SUPPLEMENTAL RESPONSES TO COMMENTS ON THE DRAFT ENVIRONMENTAL IMPACT REPORT

SFPUC Alameda Creek Recapture Project Volume 5

PLANNING DEPARTMENT
CASE NO. 2015-004827ENV
STATE CLEARINGHOUSE NO. 2015062072
APRIL 1, 2020

Figure HYD4-3

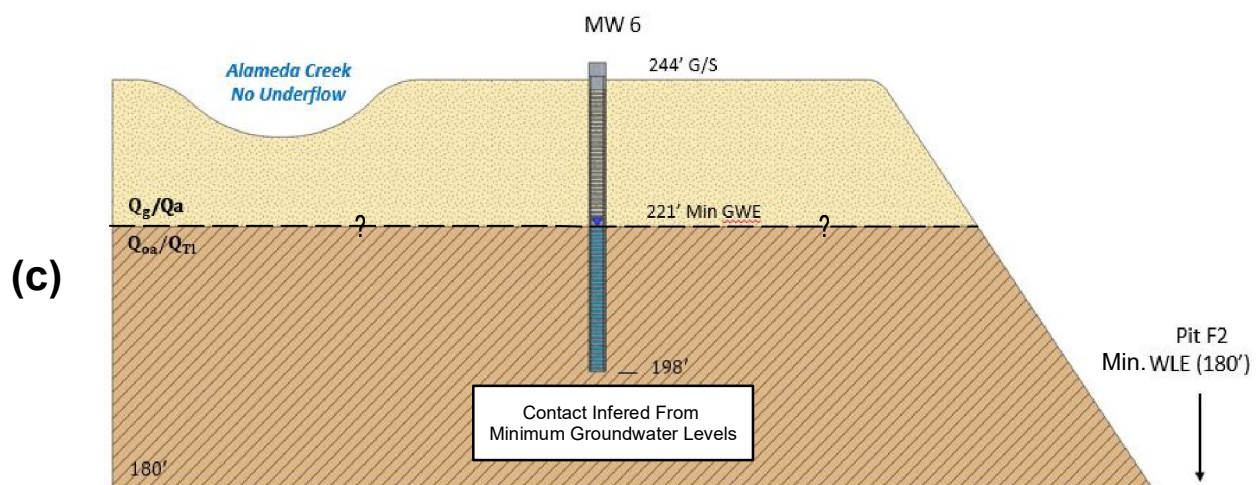
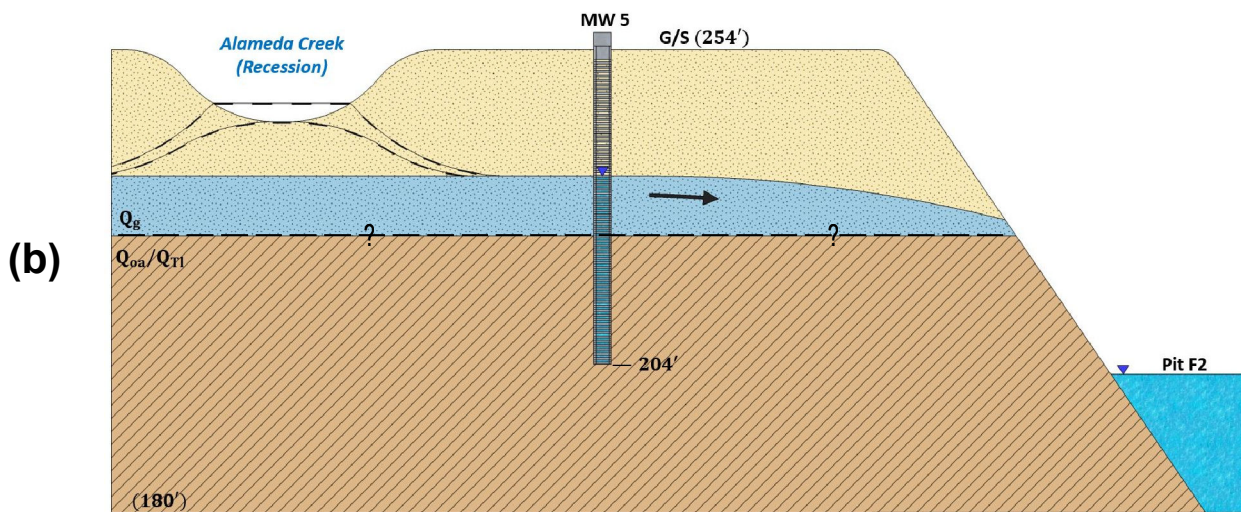
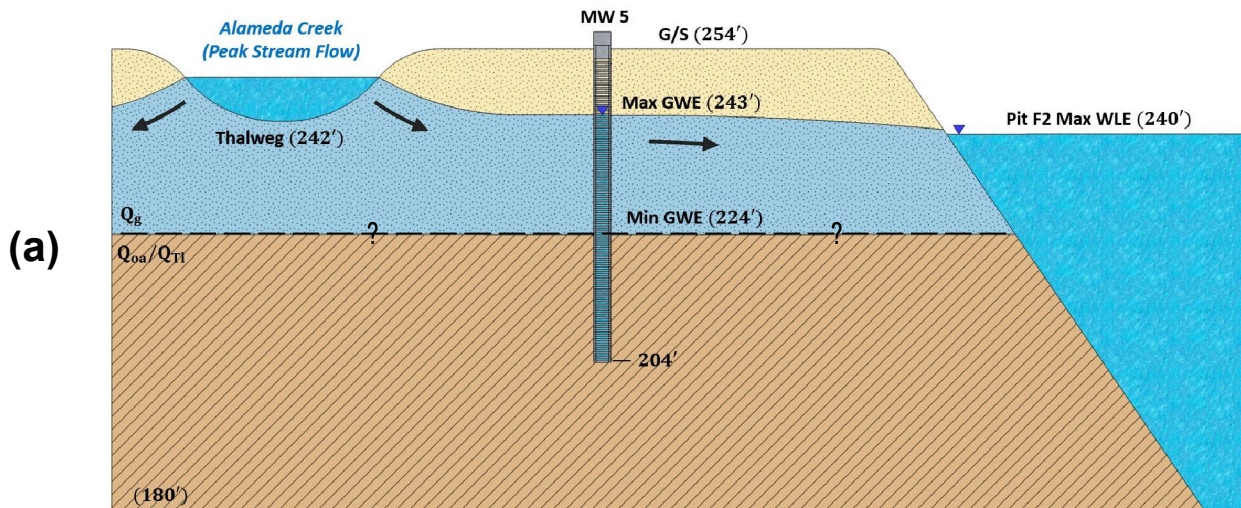
Can you please provide an explanation of the path through which the increased streamflow is assumed to travel into Pit F2 and which would allow for this additional pumping?” (*Robert Shaver, General Manager, Alameda County Water District, letter, December 18, 2019 [A-ACWD3-4]*)

Response HY-13: Inflow to Pit F2

Comment A-ACWD3-4 requests an explanation of the path through which the increased streamflow is assumed to travel into Pit F2. While the implementation of CDRP releases will increase the volume of water in the creek, and therefore the volume of water entering Pit F2, the pathways by which water enters Pit F2 remain unchanged from the existing condition. These pathways are best depicted in Figure HYD4-3 in Appendix HYD1-R and Figure 7-4 in Appendix HYD2-R. Figure HYD4-3 is a simplified schematic showing the various pathways of water entering and leaving Pit F2. Key inputs into the pit are labeled (A) through (C); inputs and outputs deemed constant between scenarios (e.g., precipitation and evaporation) are not shown. As evident in the figure, water enters the pit through three primary pathways: as subsurface flow from upstream quarry pits (A), as runoff from the small watershed to the east of the pit (B), and as direct seepage from Alameda Creek between the cutoff walls surrounding the pit (C). Figure 7-4 from Appendix HYD2-R illustrates the mechanism by which direct seepage into Pit F2 from Alameda Creek occurs.

As described in Appendix HYD2-R, pp. 22 to 23, Figure 7-4 is a three part cross-sectional schematic of Alameda Creek in the vicinity of monitoring well 5, just upstream of Pit F2, under various conditions. Figure 7-4(a) shows the conditions with maximum observed groundwater levels and maximum storage levels in Pit F2; Figure 7-4(b) shows the recession of groundwater with declining streamflow, and Figure 7-4(c) shows the minimum observed groundwater level corresponding to the interpreted base of the shallow aquifer. Under conditions shown in Figure 7-4(a) and (b), subsurface water in the shallow aquifer would flow towards Pit F2. Figures HYD4-3 and 7-4 are reproduced on the following two pages.

Comment A-ACWD4-2 also requests clarification on sources of inflow to Pit F2. These sources are shown on Figure HYD4-3 in Appendix HYD1-R, as described above, which states that water enters the pit through three primary pathways: as subsurface flow from upstream quarry pits (A), as runoff from the small watershed to the east of the pit (B), and as direct seepage from Alameda Creek between the cutoff walls surrounding the pit (C). When the CDRP instream bypasses and releases are implemented, there will be year-round flow in Alameda Creek upstream of Pit F2, and inflow from (A) and (C) is expected to increase compared to existing conditions, while (B) will remain the same. The major source of increased inflow to Pit F2 is (A), subsurface flow from upstream quarry pits. This additional inflow would allow for the pumping proposed under the ACRP. The commenter is correct in assuming that under the ACRP, discharges from other quarry pits would not be pumped into Pit F2. Please also refer to Response PD-3, above, which states that the EIR text will be clarified to state that under ACRP operation, Pit F2 would not receive water that is pumped from other pits or storage ponds.
